5.7 OUTCOMES OF ADVERTISING: DRAFT PRECINCT STRUCTURE PLAN AND DRAFT PLACE PLAN - LEEDERVILLE; AND PREPARATION OF AMENDMENT 7 TO LOCAL PLANNING SCHEME NO. 2

Leederville Town Centre Place Plan Summary of Submissions

Figure 3 - Village Sub-Precinct requirements

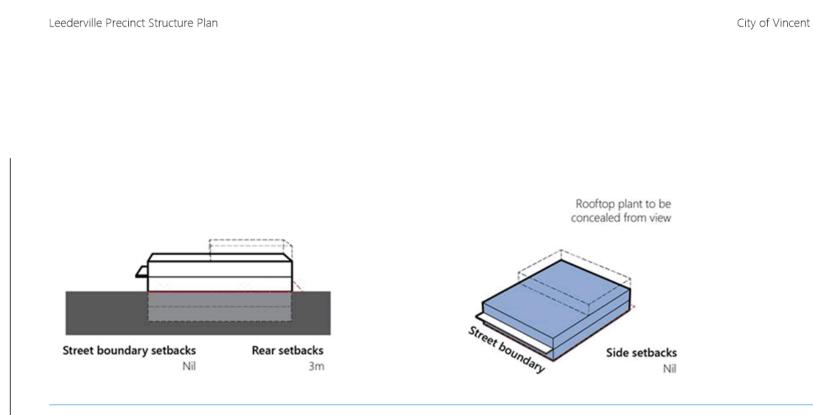
| No. | Clause Number | Page | Recommended Modification |
|-----|-----------------------|------|--|
| 10 | | 0.5 | Modify figure 3 – Remove reference to building height. |

Figure 4 - Cityscape Sub-Precinct requirements

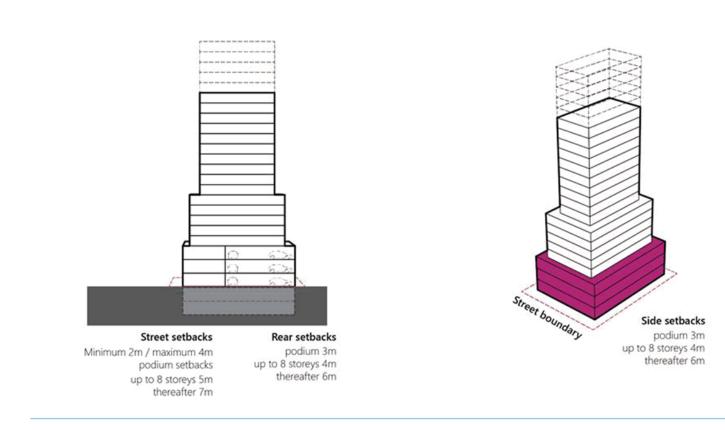
| GEN | IERAL - Administrative | | | | |
|-----|---|-----------|--|--|--|
| | Figure 4 – Cityscape Sub Precinct: The podium primary setbacks shown in the massing diagrams and text do not correspond with the setback provisions in 5.3.2. | | Amend diagrams, plan 1 and plan 2 to match the provisions. | Align Part 1 diagrams, plans and provisions. | |

| No. | Clause Number | Page | Recommended Modification |
|-----|-----------------------|------|--|
| | | | Modify figure 4 by removing references to building height. |

Figure 6 - Urban Frame Type C Sub-Precinct requirements

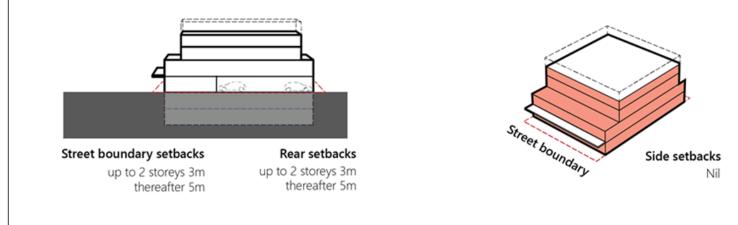
| No. | Clause Number | Page | Recommended Modification |
|-----|-----------------------|------|--|
| | | | Remove reference in figure 6 to building height. |

Figure 30 - Built Character areas

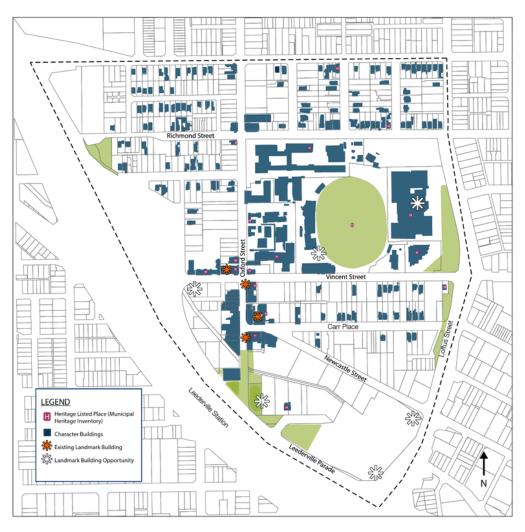
| 05 S | ENSITIVE DESIGN | | | |
|------|---|-----------|---|---|
| | To avoid ambiguity, the location of "Character Buildings" should be linked to Figure 30. | | As per 64 above. | As per 64 above. |
